Changes from V2 to V3

Title EtherCAT Corner 5: Right Rail		
Size B	Number D1200132	Revision 3
Date: 10/11/2013	Sheet 2 of 4	
File: D:\Users\...\EtherCATCornerE4.SchDoc	Drawn By: Daniel Sigg

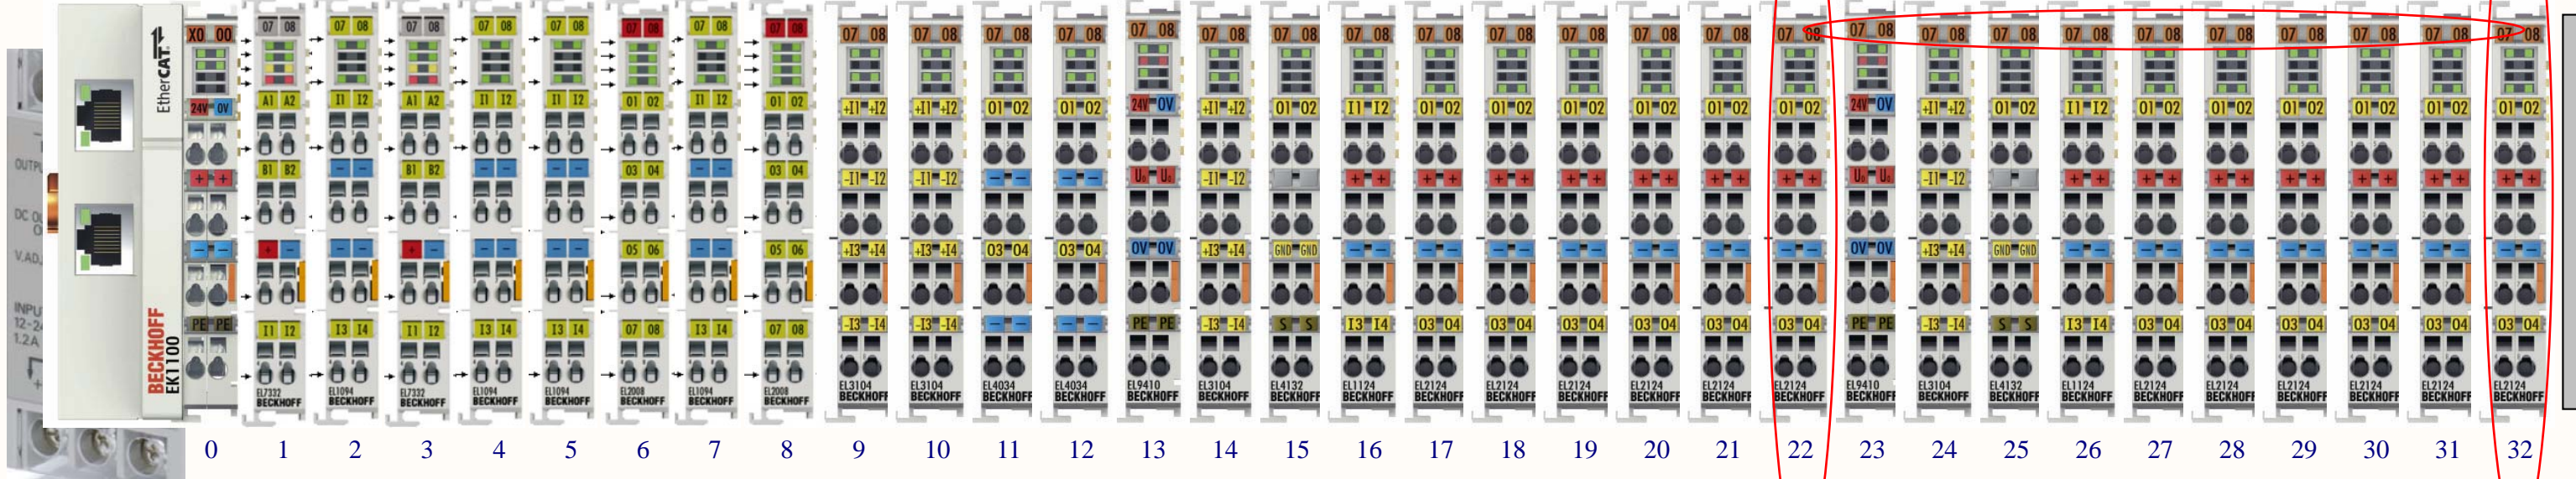
Remove label of slot #22 and add it to one of the terminals (#31)
Move labels #23 to #30 one slot over; add #31 at the end
Move terminals as far to the front as possible
Make space for new terminal 22
Add Terminals 22 and 32 to rail.
Hook wires to slot 2 and 3 according to E1200077v3

Relabel

New

New
